#### **Grandstream Networks, Inc.**

# Request for Class II Permissive Change

FCC ID: YZZHT701V21 Data: January 15, 2016

Original mainboard photo view

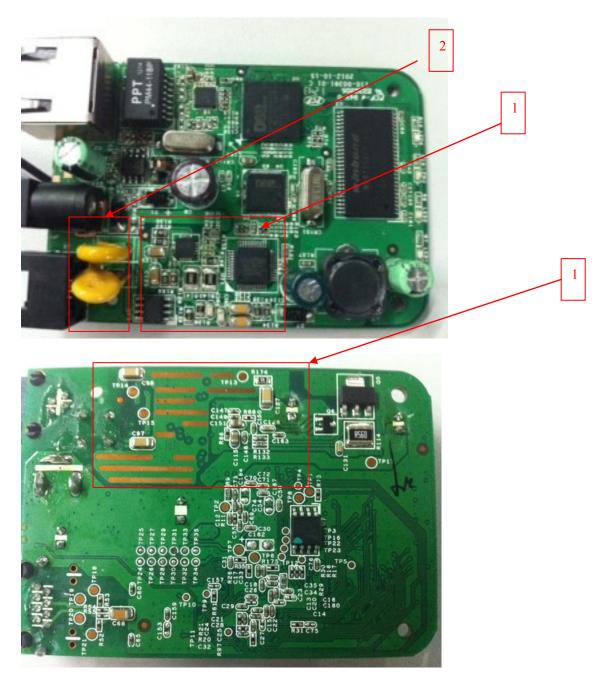
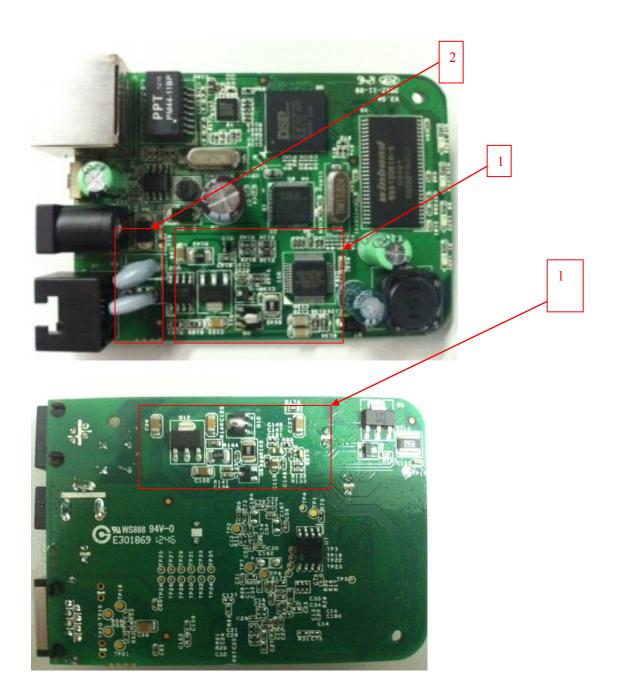
- 1. Upgraded mainboard hardware version from HT701 V2.1to HT701V3.0;
- 2. Changed component layout& PCB layout, we only replace an integrated chip (N681622YG) by discrete circuit for better performance(see arrow 1);
- 3. Change PTC from 9 ohm to 50 ohm(see arrow 2);
- 4. Add two power adapter (Model: F06US1200050A/NBS05B120050VU) and has the same electrical specification with original power adapter
